UNITED STATES PATENT AND TRADEMARK OFFICE

APPLICATION NO.	FILING DATE	FIRST NAMED INVENTOR	ATTORNEY DOCKET NO.	CONFIRMATION NO.
10/816,190	04/02/2004	Steven George Hansen	081468-0309021	7518

Office Action Summary	Application No. 10/816,190	Applicant(s) HANSEN ET AL.	
	Examiner Kevin Gutierrez	Art Unit 2851

DETAILED ACTION

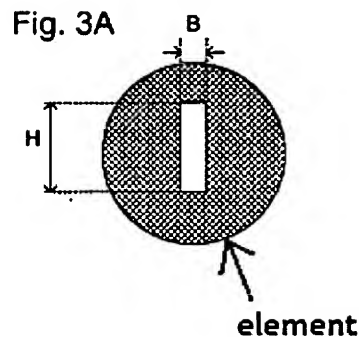
1. Applicant's arguments, see Remarks, filed June 13, 2006, with respect to the objection(s) and rejection(s) of claim(s) 1-3, 9-10 and 14-20 under 35 USC 102 and 103 have been fully considered and are persuasive. Therefore, the rejection has been withdrawn. However, the objection to the Drawings is maintained because the Applicant states the Examiner has not specifically pointed out any claim elements. The image of the referenced element is provided below. Further, the element does not contain a reference value. Appropriate correction is required.

2. The drawings are objected to under 37 CFR 1.83(a). The drawings must show every feature of the invention specified in the claims. Therefore, the location of the claimed element shown in Figure 3A (the *element*, as labeled by the Examiner in the image provided below, which is further not provided with a reference number) must be shown or the feature(s) canceled from the claim(s). No new matter should be entered.

Corrected drawing sheets in compliance with 37 CFR 1.121(d) are required in reply to the Office action to avoid abandonment of the application. Any amended replacement drawing sheet should include all of the figures appearing on the immediate prior version of the sheet, even if only one figure is being amended. The figure or figure number of an amended drawing should not be labeled as “amended.” If a drawing figure is to be canceled, the appropriate figure must be removed from the replacement sheet, and where necessary, the remaining figures must be renumbered and appropriate changes made to the brief description of the several views of the drawings for consistency. Additional replacement sheets may be necessary to show the renumbering of the remaining figures. Each drawing sheet submitted after the filing date of an application must be labeled in the top margin as either “Replacement Sheet” or “New Sheet” pursuant to 37 CFR 1.121(d). If the changes are not accepted by the examiner, the applicant will be notified and informed of any required corrective action in the next Office action. The objection to the drawings will not be held in abeyance.
